Access Compliance Report

Public Rights-of-Way

(Curb Ramps)

Intersection ID: 29681	Main Street: DARLINGTON_RD	Cross Street: EQUESTRIAN_DR	Location: S
ADA ID: D94F3A50B1A6	Ramp Type: PerpDiag	Initial Pass/Fail: Fail	Overall Compliance: No
		Severity Score: 22.5

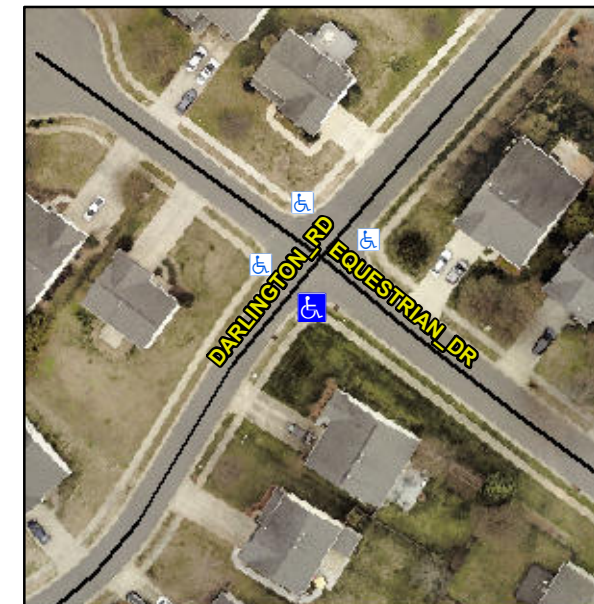
Not Found, R304.5.1, R304.2.2, R304.5.3

Compliance	Description	Data	Compliance	Description	Data
N/A	Ramp Length (in)	50.0	No	Ramp Slope (%)	9.2
No	Ramp Width (in)	42.0	No	Ramp XSlope (%)	2.9
N/A	Flare Type LT	N/A	N/A	Flare Type RT	N/A
N/A	Flare Slope LT (%)	N/A	N/A	Flare Slope RT (%)	N/A
N/A	Flare Traversable LT?	N/A	N/A	Flare Traversable RT?	N/A
N/A	Landing Length (in)	N/A	N/A	DWS Provided?	N/A
N/A	Landing Width (in)	N/A	N/A	DWS Contrast?	N/A
N/A	Landing Slope (%)	N/A	N/A	DWS Length (in)	N/A
N/A	Landing X Slope (%)	N/A	N/A	DWS Full Width?	N/A
N/A	Landing Curb? (Y/N)	N/A	N/A	DWS Offset (in)	N/A
N/A	Shared Landing?	N/A			
N/A	Gutter Ponding?	N/A	N/A	Gutter Slope (%)	N/A
N/A	Gutter Lip Ht (in)	N/A	N/A	Gutter X Slope (%)	N/A
N/A	Painted X Walk1?	No	N/A	Painted X Walk2?	No
	X Walk 1 Direction	To NE		X Walk 2 Direction	To NW
N/A	X Walk 1 Width (in)	N/A	N/A	X Walk 2 Width (in)	N/A
	X Walk 1 Slope (%)	0.5		X Walk 2 Slope (%)	1.5
	X Walk 1 X Slope (%)	1.1		X Walk 2 X Slope (%)	2.1

Remove & Replace Curb Ramp With Two New Directional Ramps or Equivalent.
